REQUEST FOR INFORMATION (RFI)

VA-251-14-B-0054

PROJECT NUMBER:	553-303a	Please ensure that before submitting questions or requests for clarification that you thoroughly read the solicitation, specifications, drawings and other pertinent documents. When submitting questions on this project the Government requires contractors to specifically identify the specification and/or solicitation section(s) or drawing number(s) in reference to the question or request for clarification submitted. No question or request for clarification will be answered by the Government unless the above requirements are met. Failure to comply may prevent the Government from responding in a timely manner.	
PROJECT TITLE:	Expand Emergency Center		
PROJECT LOCATION:	Department of Veterans Affairs VA Medical Center 4646 John R. Street Detroit, MI 48201		
SUBMITTED BY:	DBC	City/State:	
PHONE NO.:

VA ER Expansion Project# 11-0049 RFI

Sheet E-500 – Note 10

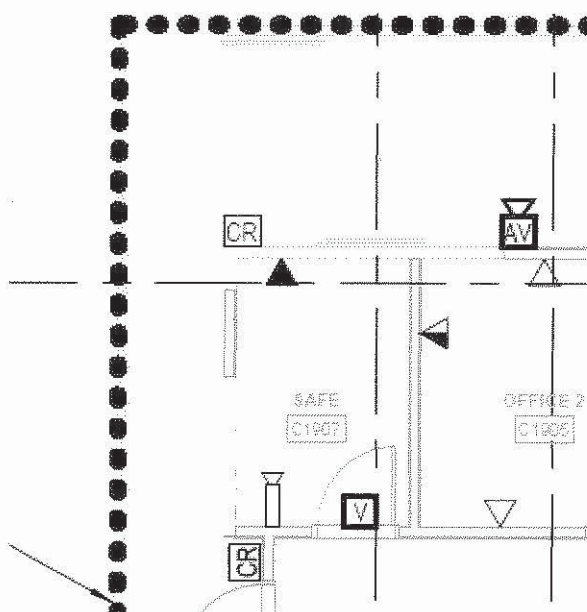
- 1- What is the scope of the Fiber Optics Work that needs to be performed
- 2- Location from and to
- 3- On sheet E-501 it is asking for rerouting and re-cabling of data cable in manhole after demolition. Is the scope of work required form us to perform that too?

1. See 10/E-502 for requirements of fiber.
2. See 10/E-502 for requirements of fiber.
3. Yes. See other RFI's for clarification of data cable.
